SAFETY EVALUATION BY THE OFFICE OF NUCLEAR REACTOR REGULATION

ALTERNATE AC SOURCE - BLACKOUT MODIFICATIONS

ENTERGY OPERATIONS, INC.

ARKANSAS NUCLEAR ONE, UNIT NOS. 1 AND 2

FIGURE 1

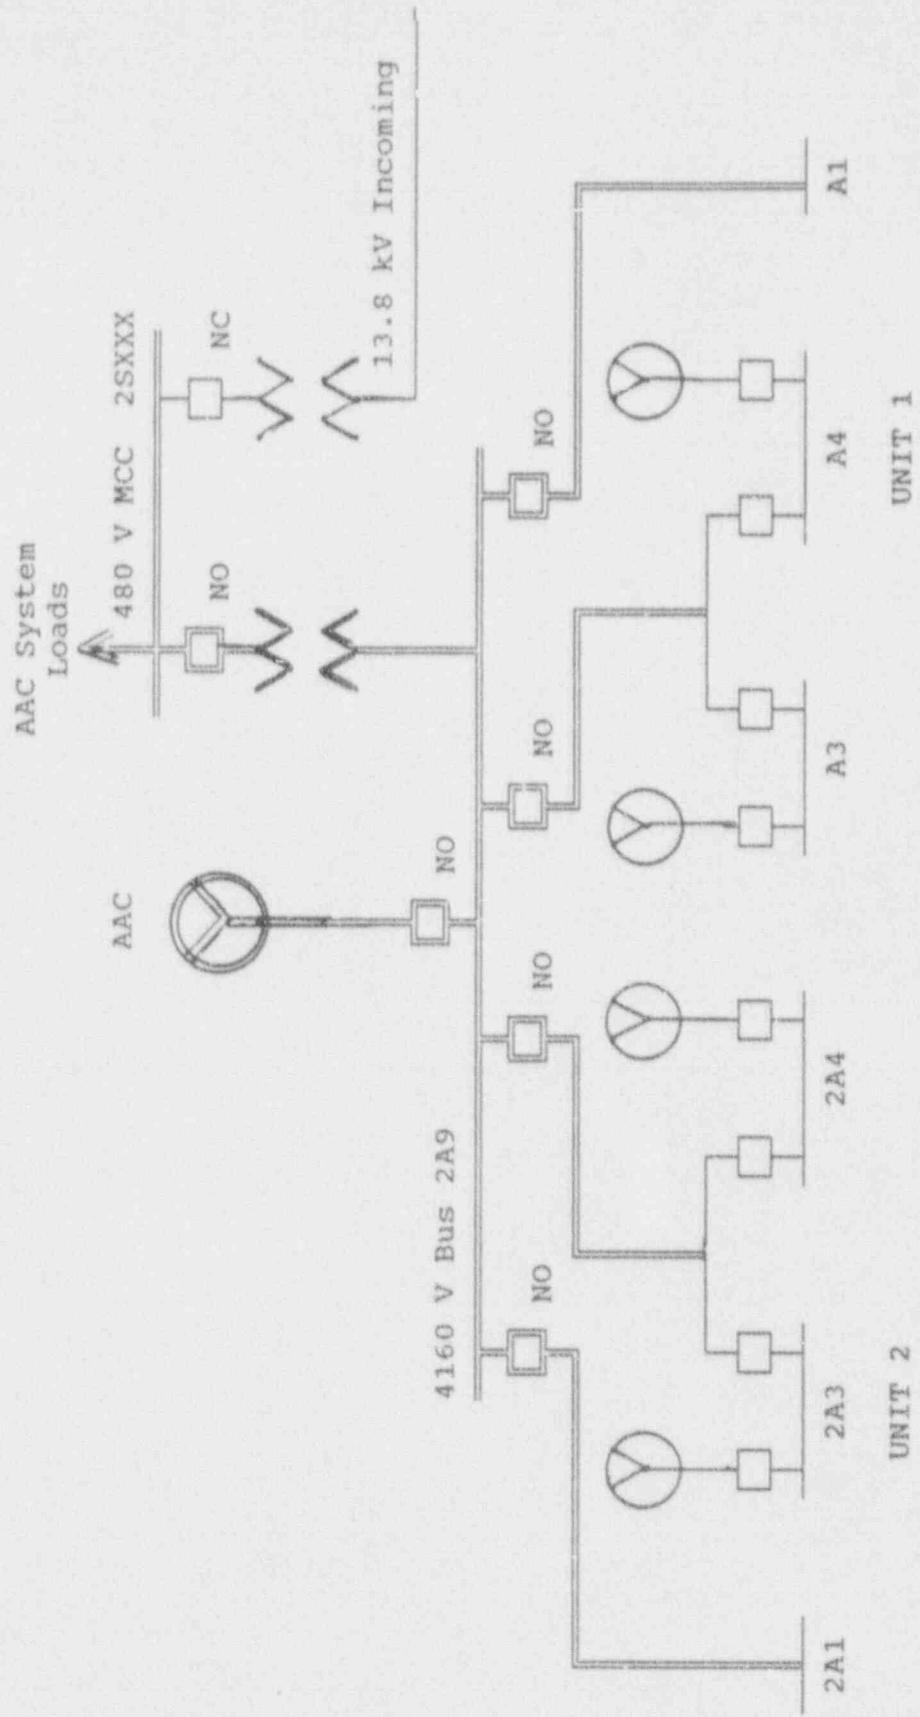
The licensee proposes to install a 4000 Kw non-class 1E diesel generator as an AAC source for SBO. The AAC source would be connectable to a new 4160 V bus (2A9). This 2A9 bus would be connectable to any of the four Arkansas Nuclear One (ANO) safety buses (A3, A4, 2A3, or 2A4) and to two of the non-safety

buses (A1 or 2A1) (see Figure 1). The diesel generator, its supporting systems, and its associated switchgear would be housed in a new diesel generator building. A new 480 V motor control center (MCC) (2Sxxx) and an associated 4160/480 V transformer would also be installed in the new building.

480 V MCC would power the AAC source supporting systems and house loads (ventilation, etc.) in the new building. A connection to an 13.8 kV/430 V transformer would be made to power the 480 V MCC during (non-blackout) conditions (see Figure 1). The proposed AAC power is not an identical machine to the emergency onsite AC power source, avoiding diversity. The staff finds this to be consistent with NUMARC Part B.8(d).

The AAC power system will interface electrically with the existing offsite and onsite ac power systems. However, electric isolation is provided between the systems by two breakers in series (see Figure 1). Based on the above, the staff concludes that failure of AAC components will not adversely affect the Class 1E ac power systems. The staff finds this to be consistent with NUMARC 87-00, Part B.5. Also, electrical isolation is provided through an appropriate isolation means. The staff finds this to be consistent with NUMARC 87-00, Part B.6.
